CITY OF STOUGHTON
DEPARTMENT OF
PLANNING & DEVELOPMENT
207 S. Forrest Street, Stoughton, WI. 53589

Subject: Agenda Item for the October 12, 2020 Plan Commission Meeting

Approving a Fence Renovation at 109-113 E. Main Street, Stoughton, WI.

I have completed a review of the proposed fencing at 109-113 E. Main Street. The downtown design overlay zoning district requirements are outlined below. This request is planned for review/approval at the October 12, 2020 Plan Commission meeting of which you will receive notice. You and/or your representative are required to attend the virtual meeting to answer questions.

BEFORE

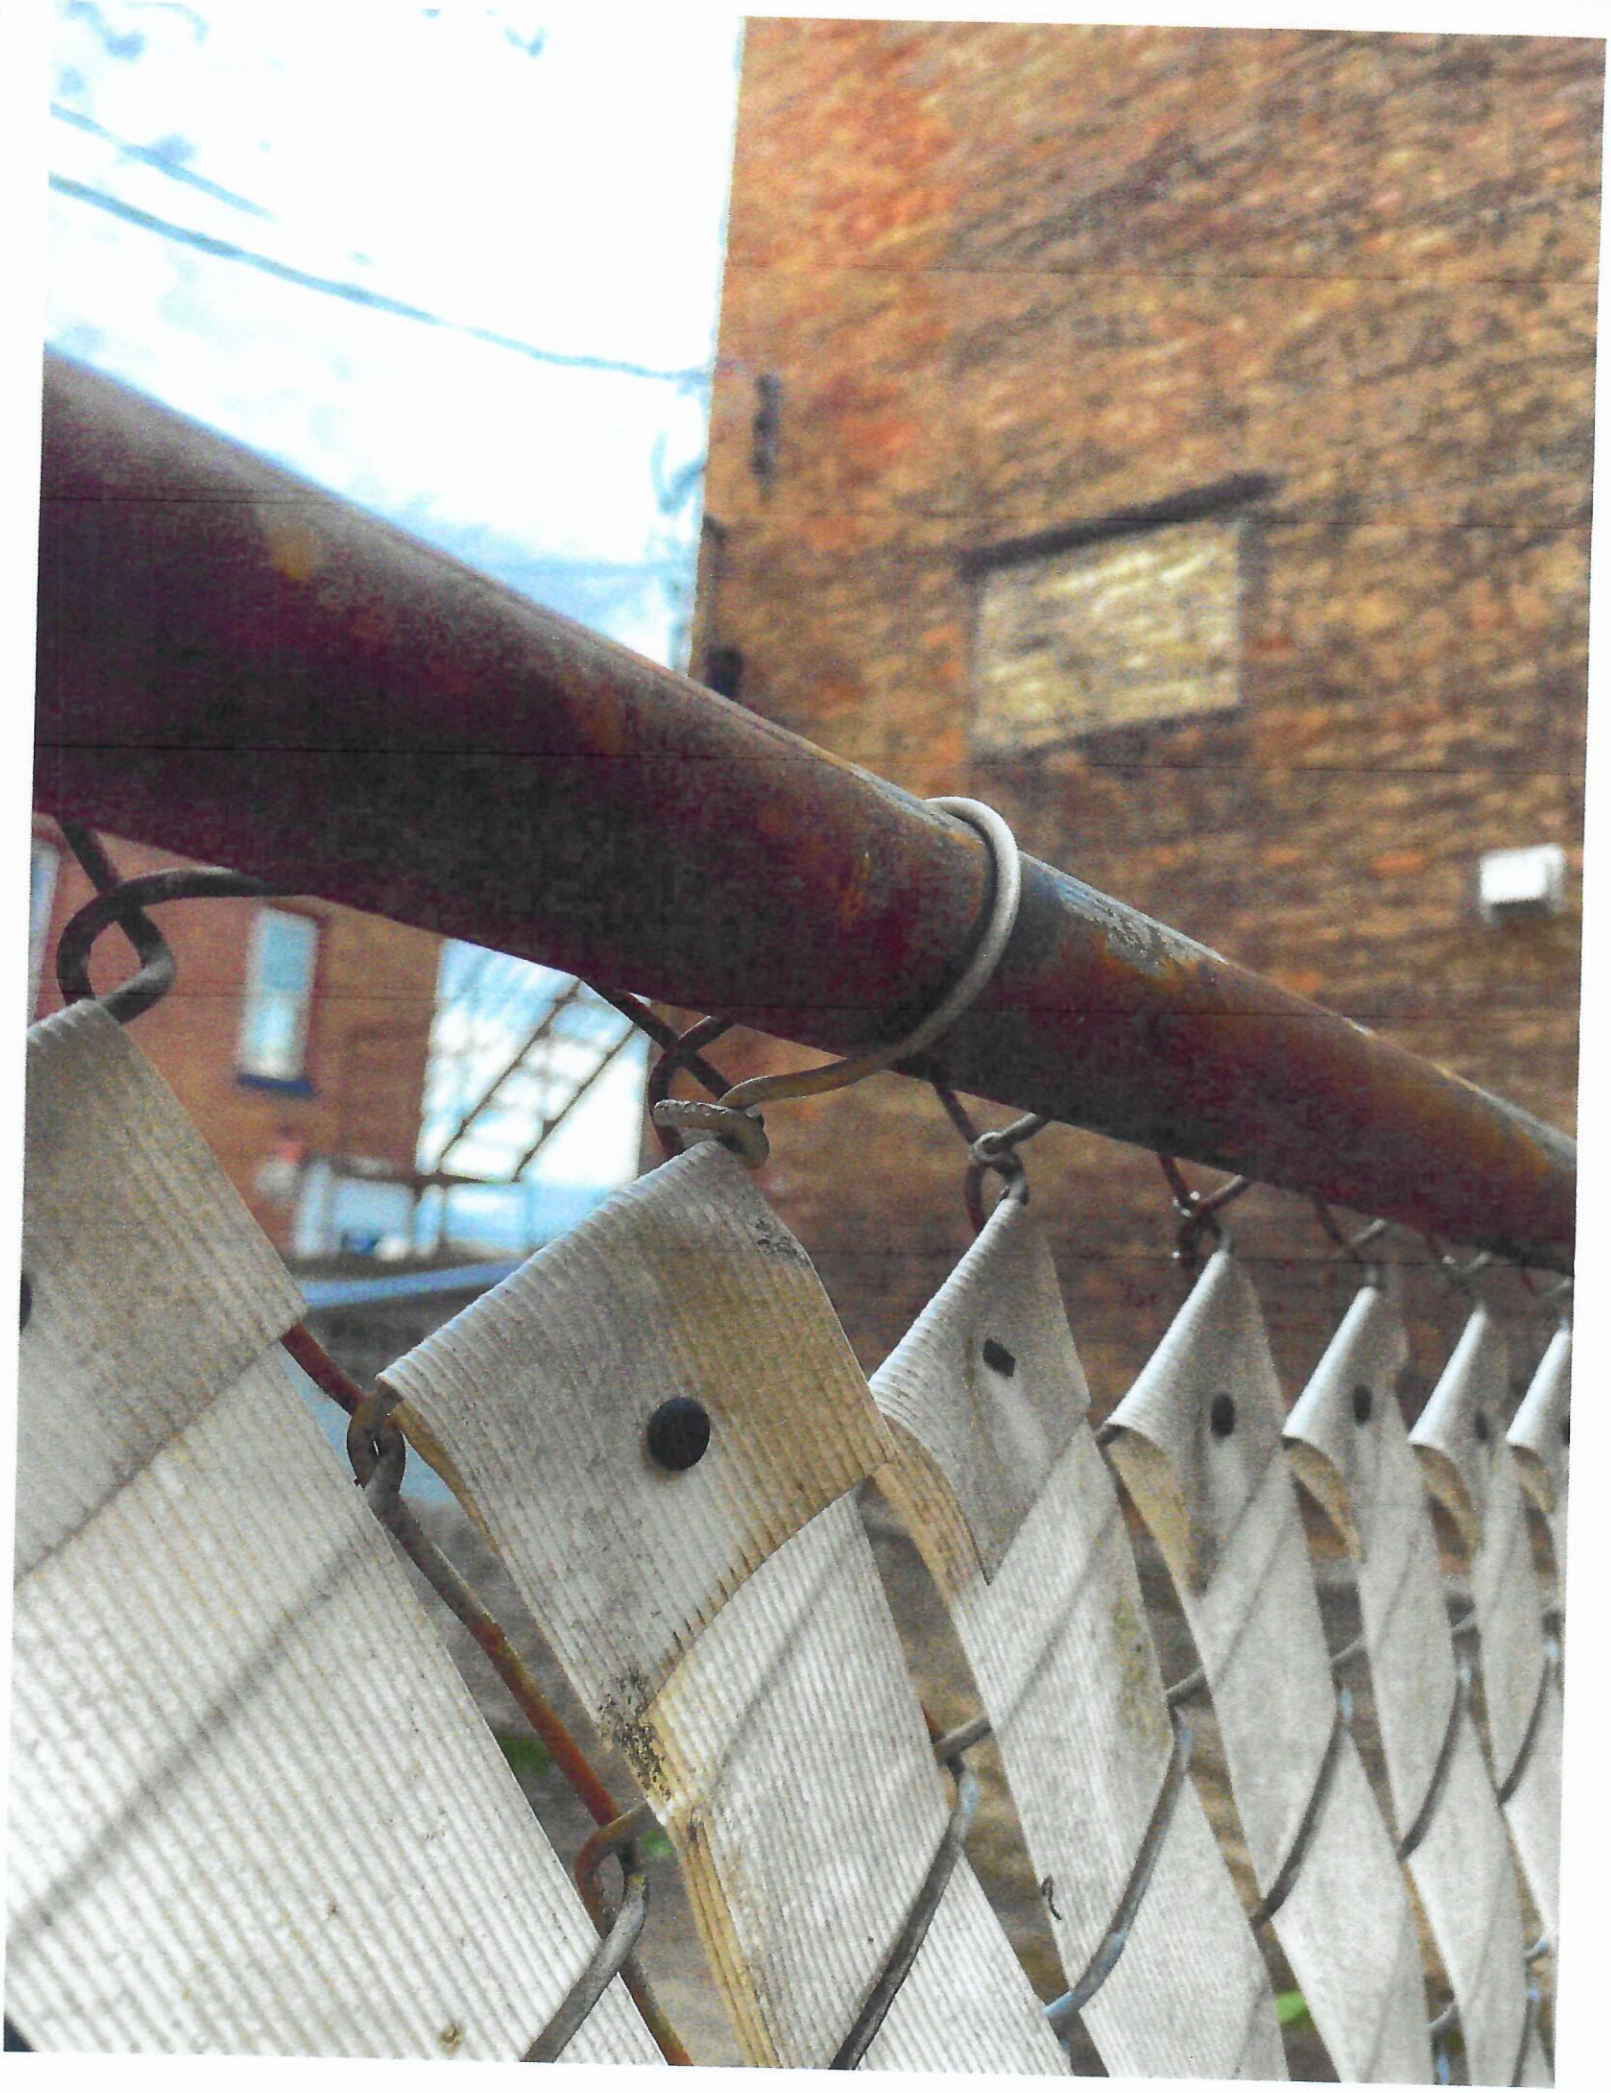
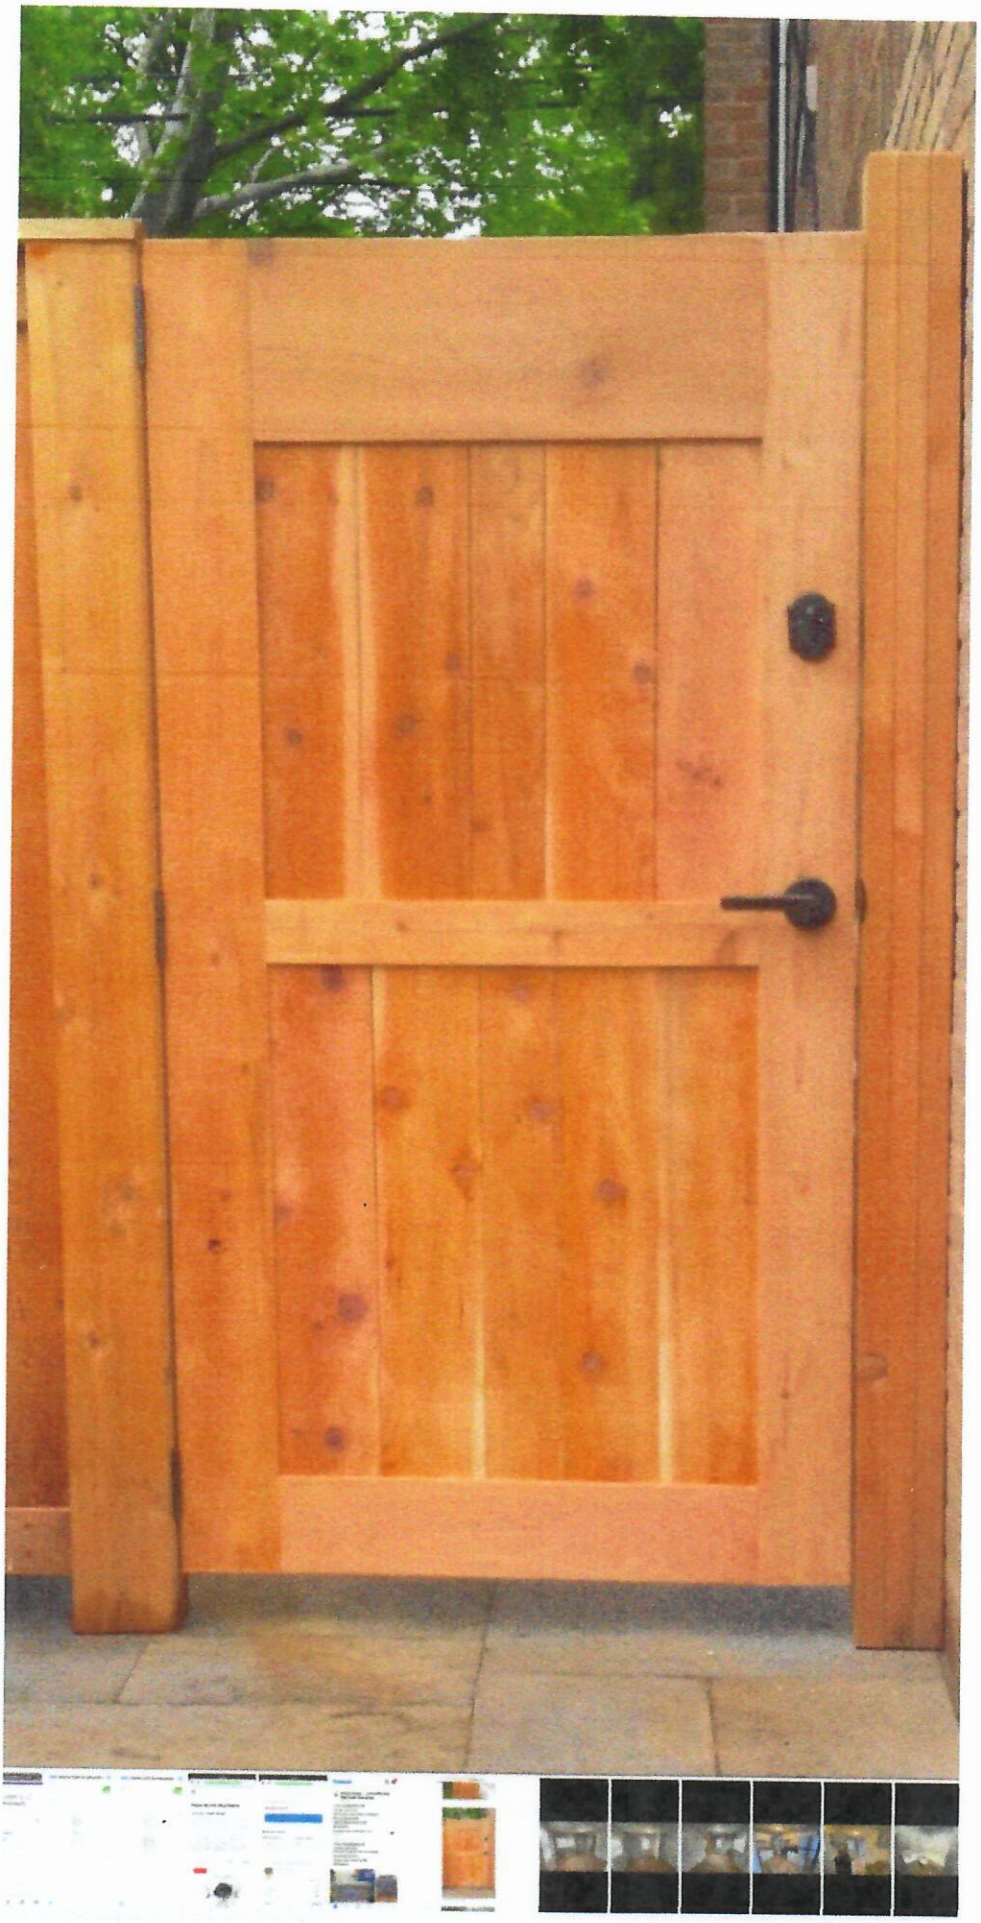
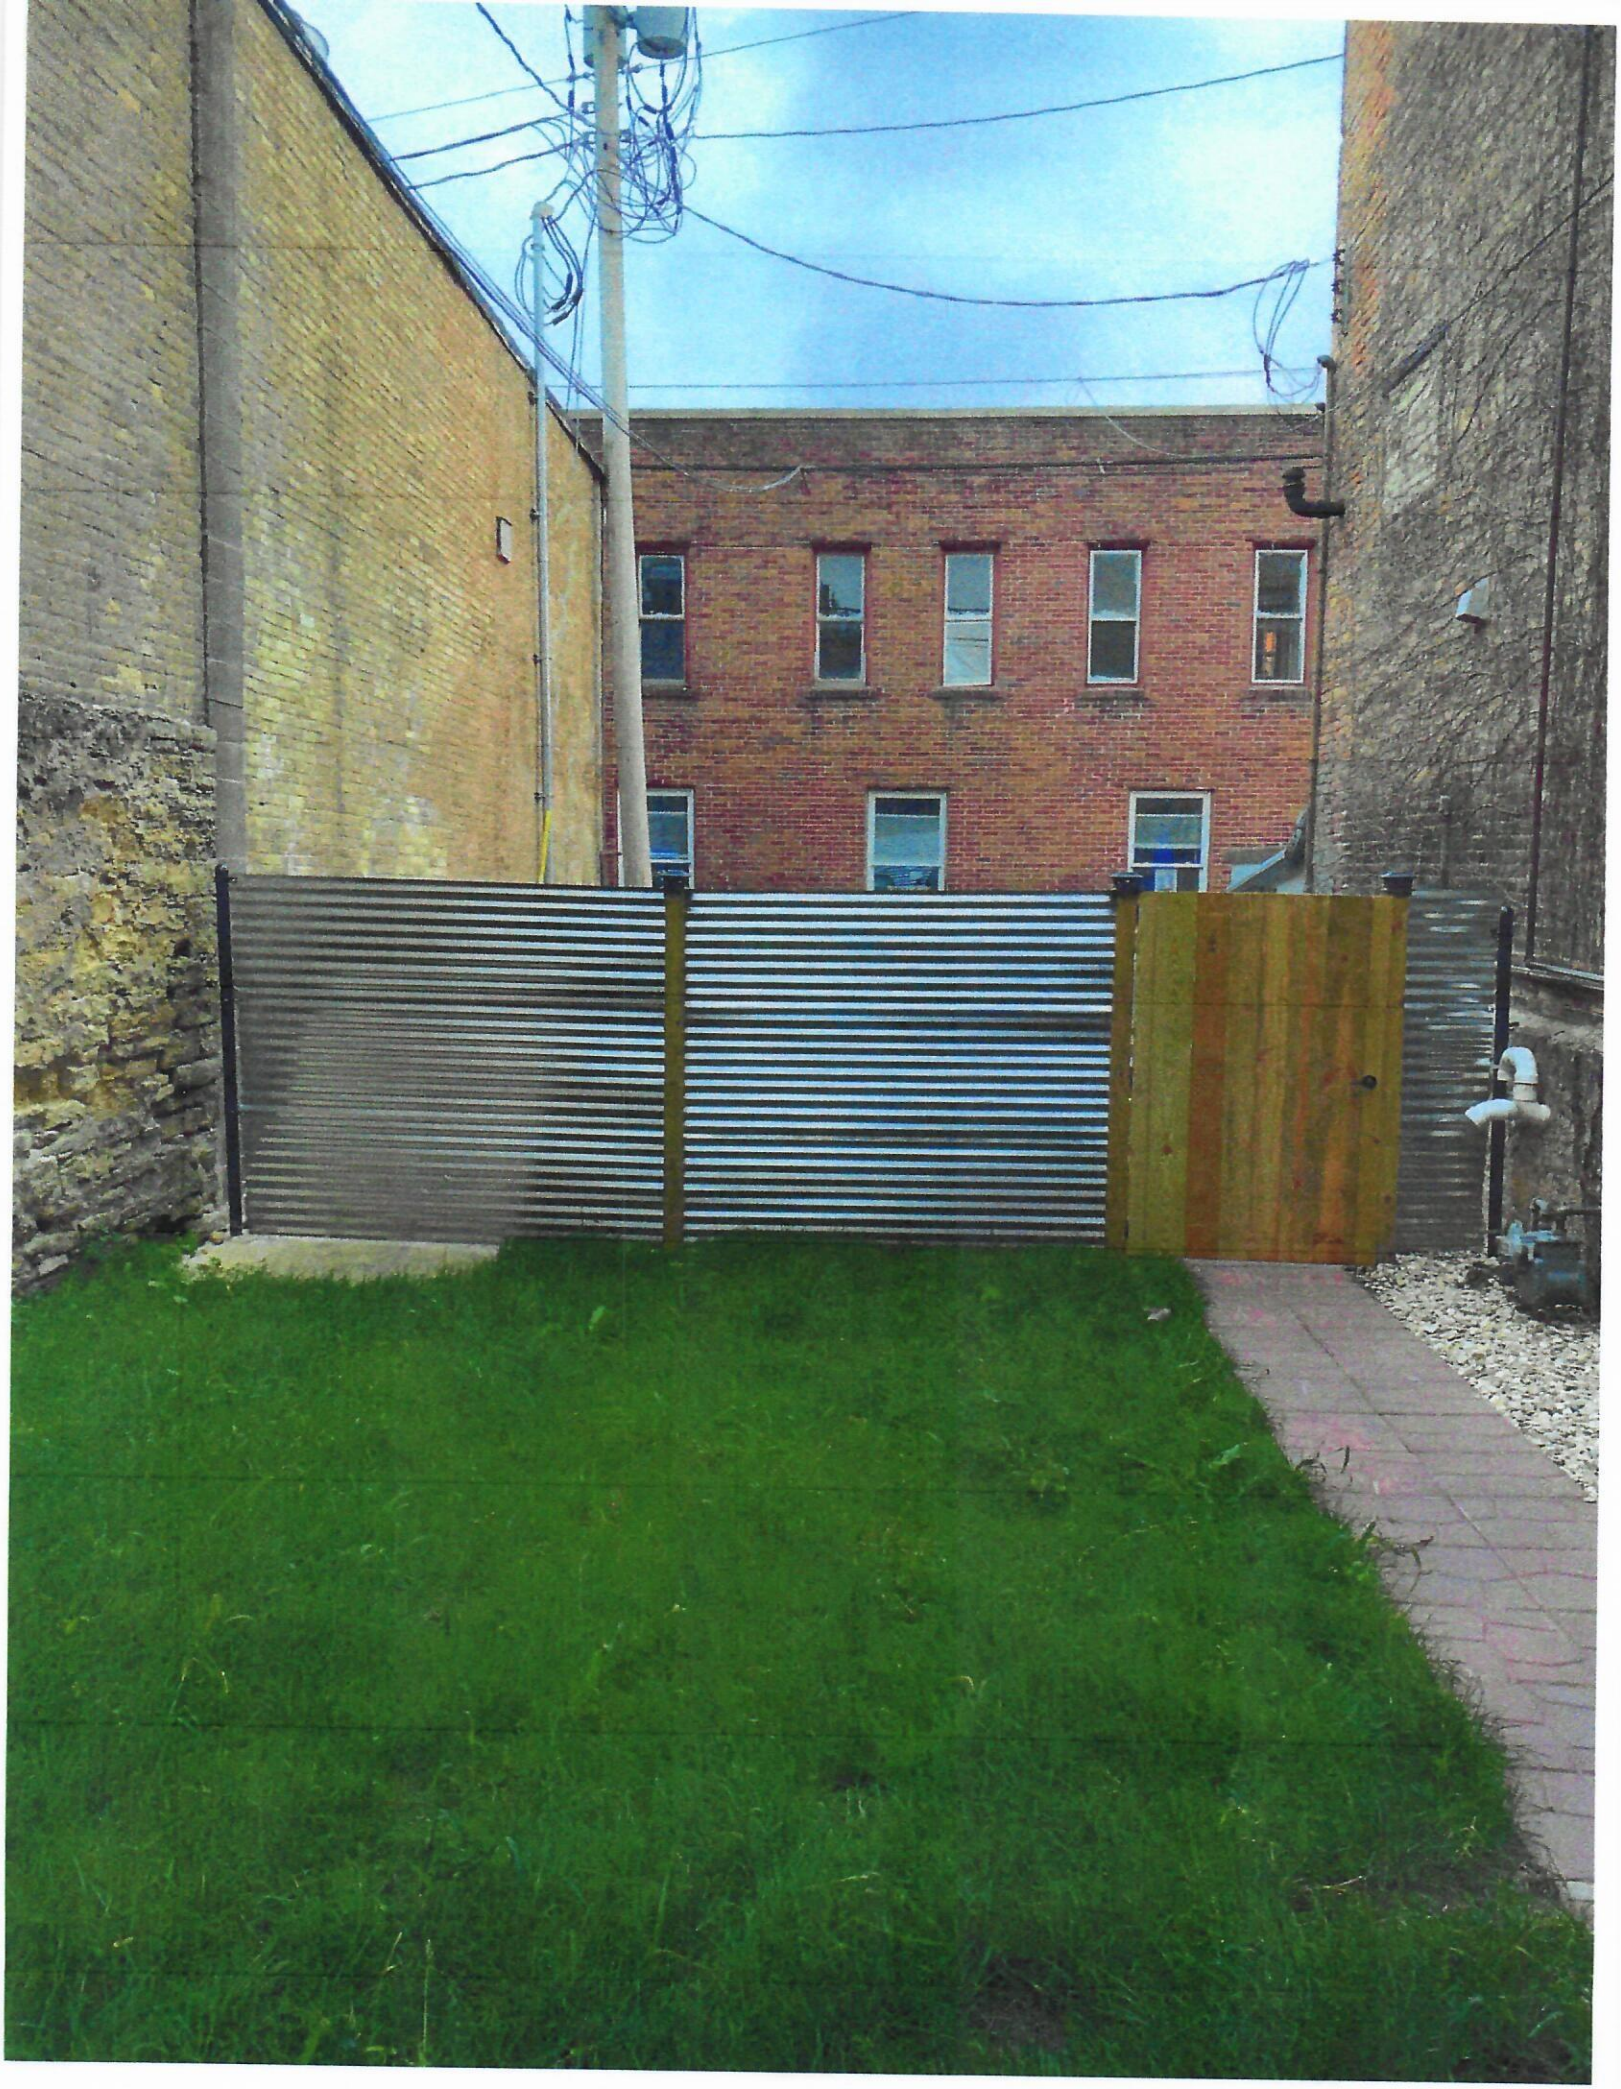
recommended and may be required by the city. **Before and after pictures are provided.**

3. A clear depiction of the proposed appearance of the property including paint charts, promotional brochures, and/or clear color photographs of replacement architectural components. Scaled or fully dimensioned drawings of proposed components such as windows, doors, railings, fencing or other site components, and/or detailed building elevations which are proposed for alteration or replacement are recommended and may be required by the city. **Pictures are provided.**
4. A clear written description of the proposed modification, including a complete listing of proposed components, materials, and colors. **Provided.**
5. A clear written explanation regarding how the proposed alteration will conform to section 78-517(7) with direct reference to each applicable design standard. **Explanation for the change is provided but not how it conforms to section78-517(7).**
